Access Compliance Report

Public Rights-of-Way

Intersection ID: 15849	Main Street: NORTON_RD	Cross Street: QUEENS_RD_WEST	Location: NW
ADA ID: 8913564B36FF	Ramp Type: PerpDiag	Initial Pass/Fail: Fail	Overall Compliance: No
Severity Score: 10			
Codes/Mitigation Info/Possible Solution		Field Measurements/Component Compliance

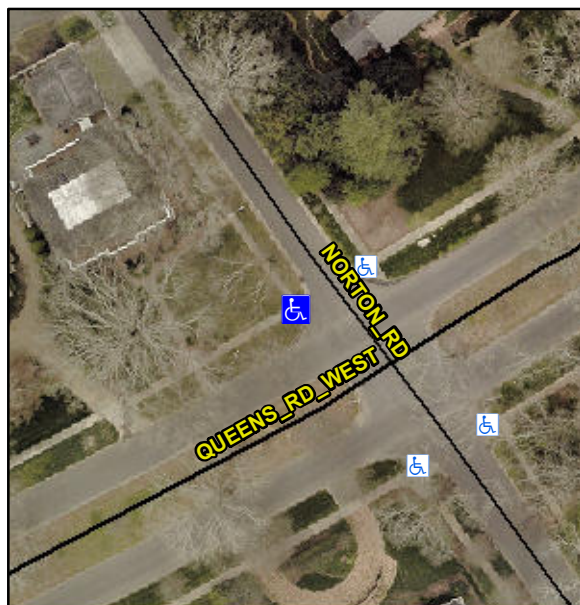
Not Found, R304.5.1, R304.5.3

Compliance	Description	Data	Compliance	Description	Data
N/A	Ramp Length (in)	26.0	Yes	Ramp Slope (%)	6.4
No	Ramp Width (in)	47.0	No	Ramp XSlope (%)	4.0
N/A	Flare Type LT	N/A	N/A	Flare Type RT	N/A
N/A	Flare Slope LT (%)	N/A	N/A	Flare Slope RT (%)	N/A
N/A	Flare Traversable LT?	N/A	N/A	Flare Traversable RT?	N/A
N/A	Landing Length (in)	N/A	N/A	DWS Provided?	N/A
N/A	Landing Width (in)	N/A	N/A	DWS Contrast?	N/A
N/A	Landing Slope (%)	N/A	N/A	DWS Length (in)	N/A
N/A	Landing X Slope (%)	N/A	N/A	DWS Full Width?	N/A
N/A	Landing Curb? (Y/N)	N/A	N/A	DWS Offset (in)	N/A
N/A	Shared Landing?	N/A			
N/A	Gutter Ponding?	N/A	N/A	Gutter Slope (%)	N/A
N/A	Gutter Lip Ht (in)	N/A	N/A	Gutter X Slope (%)	N/A
N/A	Painted X Walk1?	No	N/A	Painted X Walk2?	No
	X Walk 1 Direction	To SE		X Walk 2 Direction	To E
N/A	X Walk 1 Width (in)	N/A	N/A	X Walk 2 Width (in)	N/A
	X Walk 1 Slope (%)	1.7		X Walk 2 Slope (%)	0.9
	X Walk 1 X Slope (%)	2.1		X Walk 2 X Slope (%)	0.7

Remove & Replace Curb Ramp With Two New Directional Ramps or Equivalent.
